FlexPLI

Pre- and Post-Test Procedure

6th Meeting of Informal Group GTR9 Phase 2
Washington DC, March 19th - 20th, 2012

Proposal for Amendment 2 (DRAFT-ver.121206)

Example

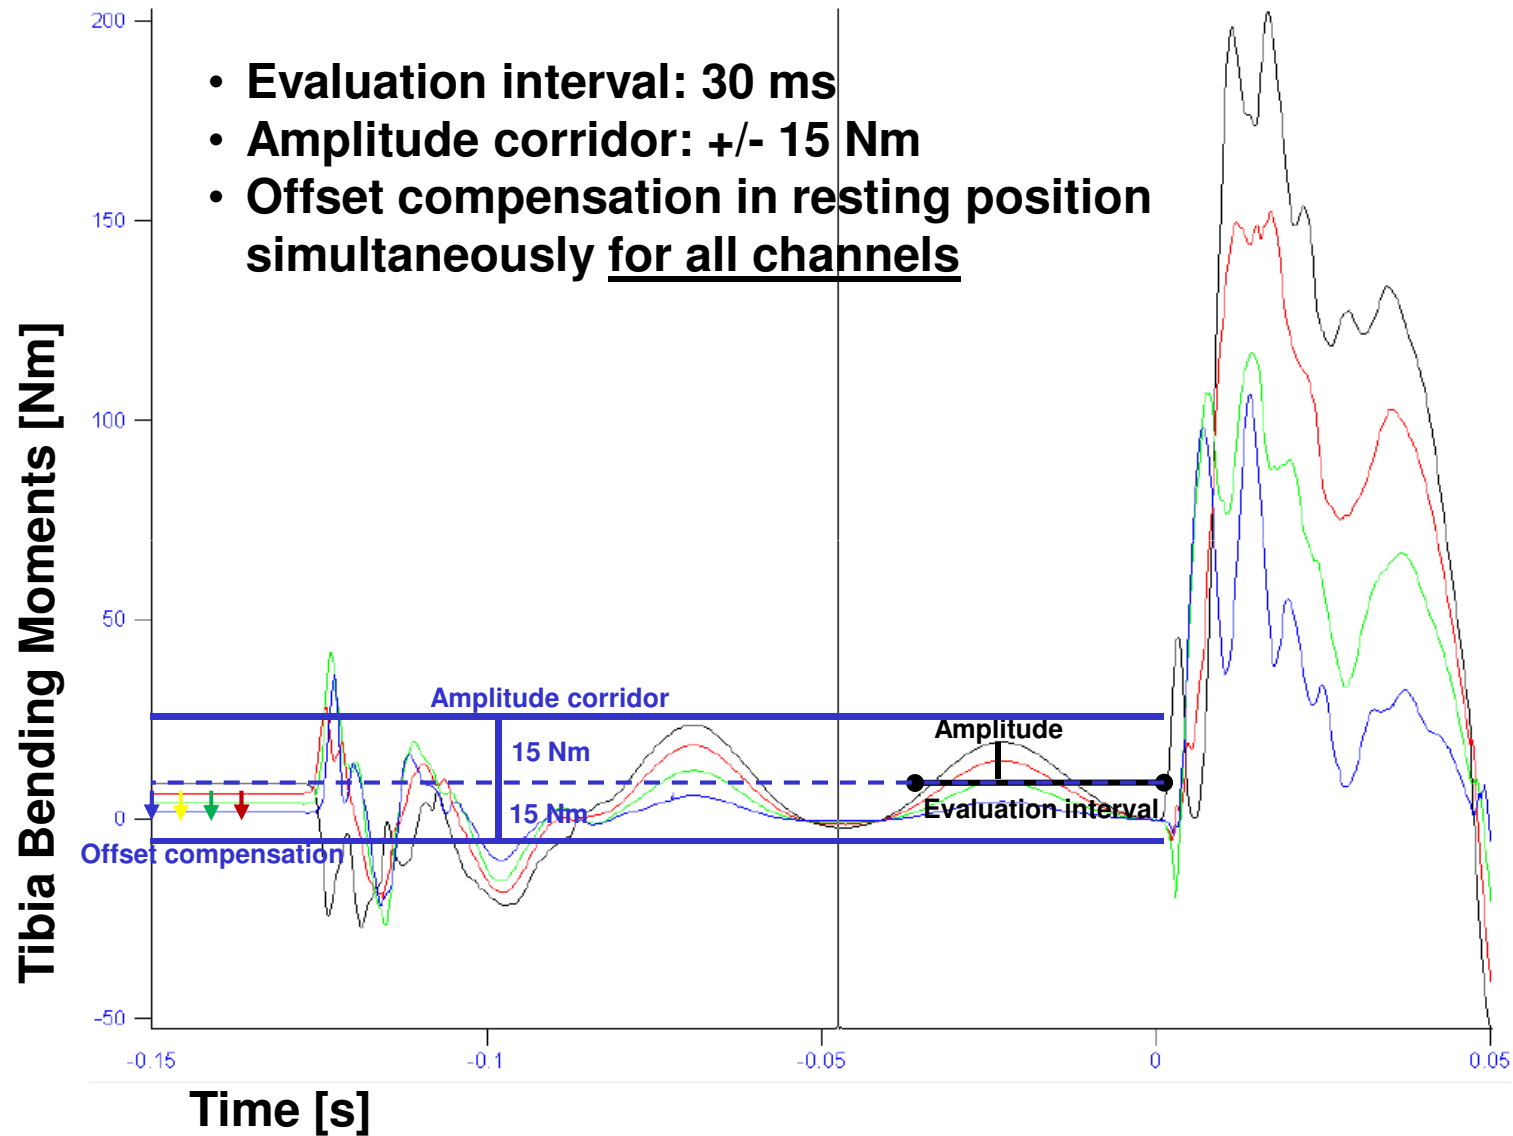
- **Several time history curves of vehicle impacts with different Flex PLI legforms were analyzed.**
- **The vibrations of the legforms during the free flight have a period length of approx. 50 ms**
=> To ensure to cover at least one – positive or negative – maximum, a time interval of 30 ms before impact is necessary.
- **In almost all cases the vibrations of the legform immediately before impact were less than 30 Nm measured from negative to positive amplitude.**
=> A limitation to ± 15 Nm is feasible
- **An offset compensation at time of first contact seems not appropriate.**

- 1. The bending moments shall be +/- 15 Nm within an evaluation interval of 30 ms immediately prior to impact**
- 2. The offset compensation shall be done with the FlexPLI impactor in resting position prior to the test / acceleration phase**
